IFB Addendum #2 San Mateo County Harbor District Oyster Point Marina Entrance Nav Aids Replacement Project

CONTRACT NO. 2020-04

Questions, Clarifications, Requests for Modifications

Date: September 24, 2021

6 LADDER DETAIL
SCALE: 1" = 1'-0"

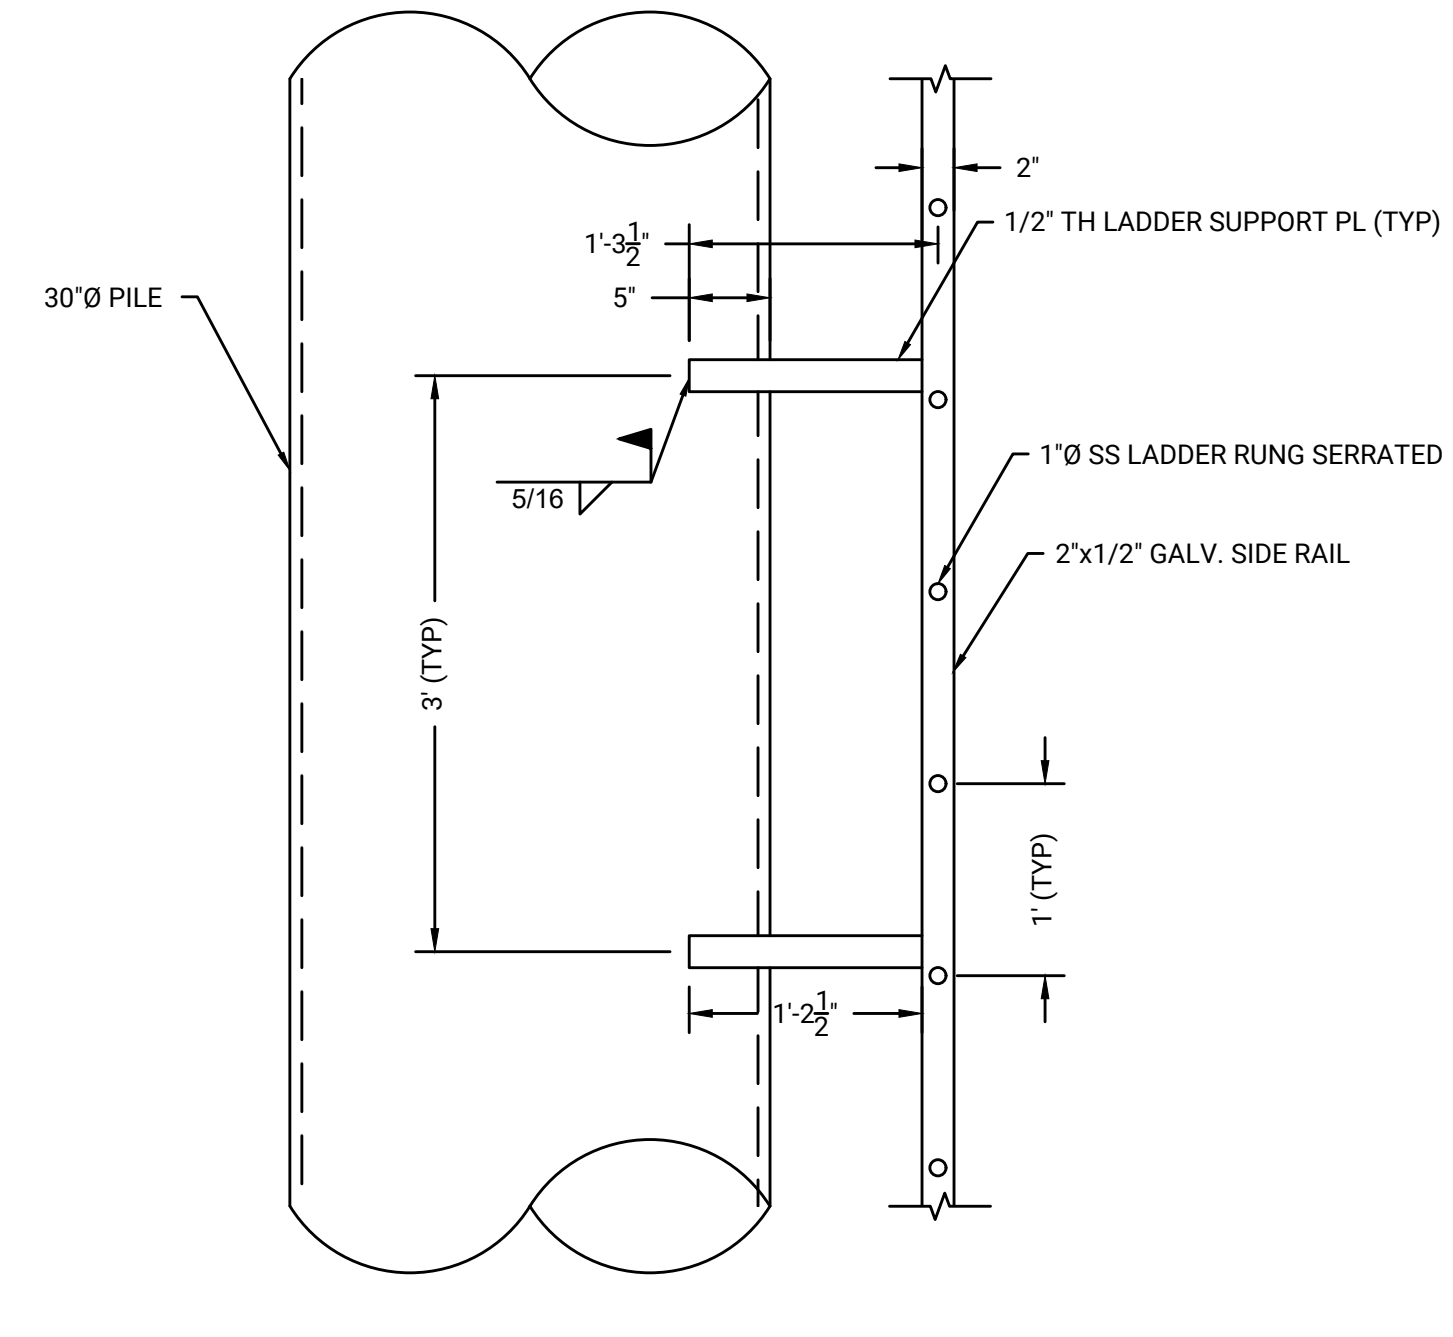
Q13: How are the ladder rung attached? Are they welded, bolted?

Q14: What is the thickness of the pile cap shown on sheet S-102?

A13: Ladder rungs shall be welded.

A14: Pile cap is 0.75 inches thick.
